Possible Mods
to ensure stability

J1/T7 mini-micro fuel cell simulator.

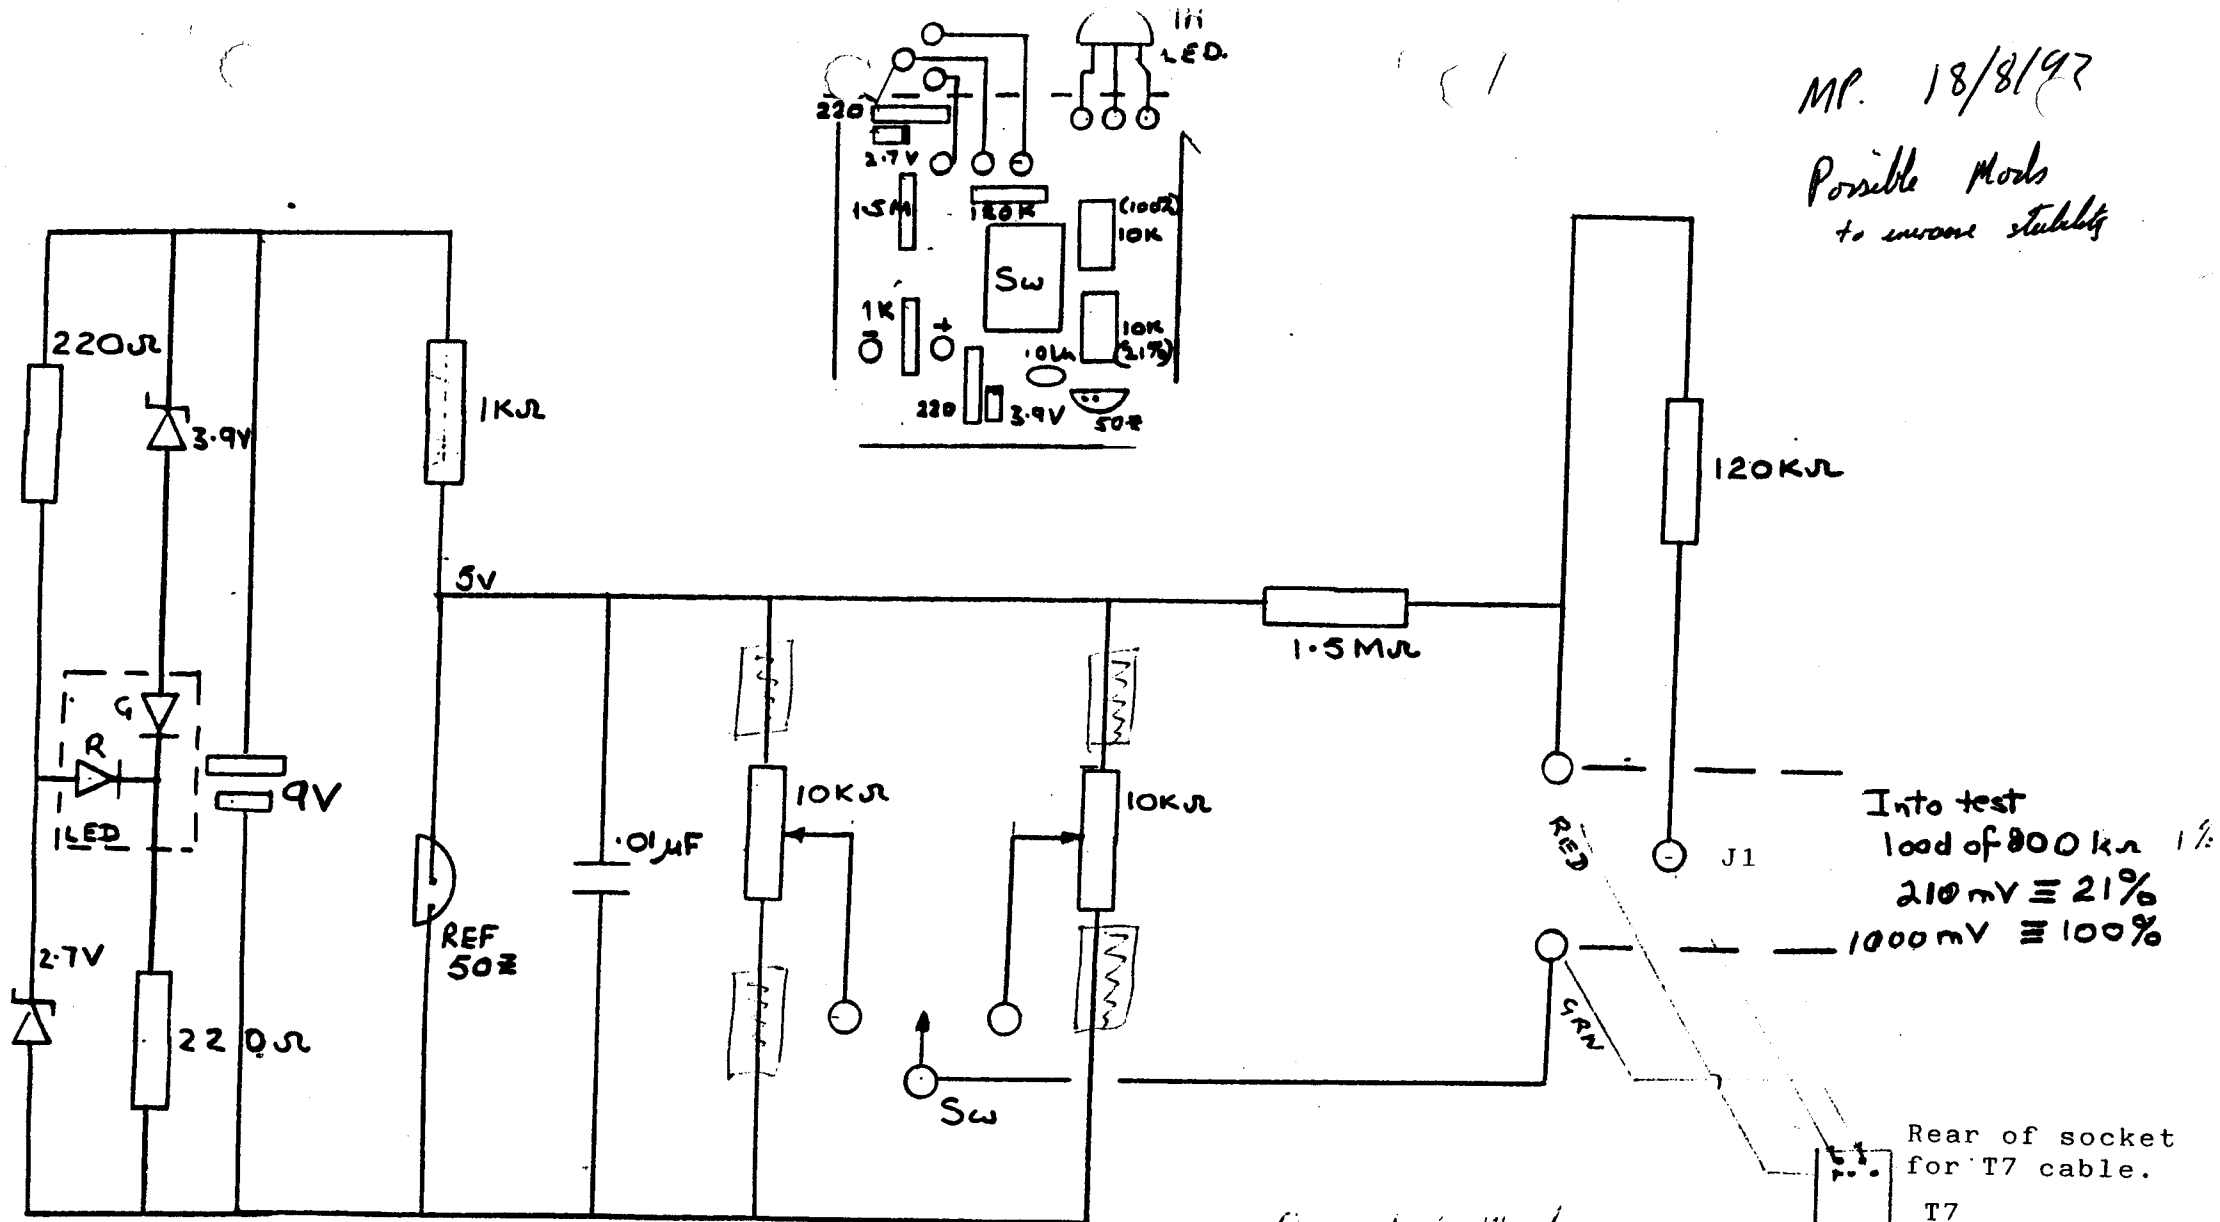
Into test
load of 800kΩ 1%
210mV $\equiv$ 21%
1000mV $\equiv$ 100%

Suggested Mod

Remove 10KΩ resistor
in series to give same o/p voltages
into 1KΩ
